30-039-05648 CLARK #003

Re: Permanent Abandonment
Well: Clark 3

P&A Procedure

Proposed P&A

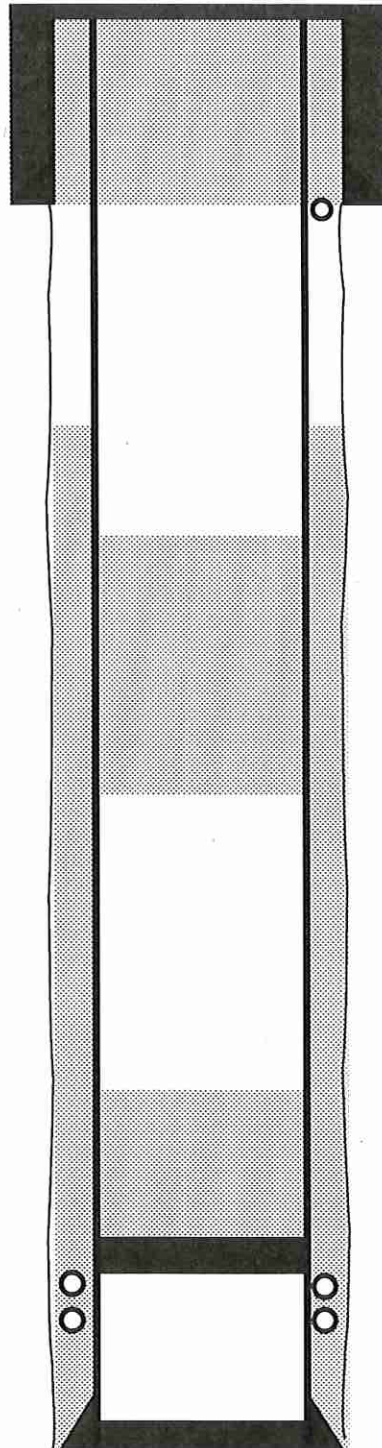
- Notify NMOCD 24 Hours prior to commencing activities
- In addition to the BLM approved plugs
- Include a plug 1500-1400/ OCD Nacimiento pick @ 1450.'
- Include a plug 3053-2705. BLM Kirtland pick @ 3003,' OCD Ojo Alamo pick @ 2755.'

- Please ensure that the tops of the Pictured Cliffs and Fruitland formations as well as the entire Ojo Alamo aquifer, identified in this report, are isolated by proper placement of cement plugs. This will protect the freshwater sands in this well bore.

Please note that the BLM geologist's picks for the Nacimiento, Ojo Alamo, and Kirtland formations vary significantly from the operator's picks. The Fruitland varies slightly.

- a. BLM Fruitland formation top (3071 ft md). Modify Plug 1: 3236 – 3021 ft
 - b. BLM Ojo Alamo formation top (2801 ft md). Plug: 2851 – 2751 ft
5. Minimum surface plug is 50 feet deeper than surface casing to surface. Perforate production casing at least 216 feet or deeper for surface plug.
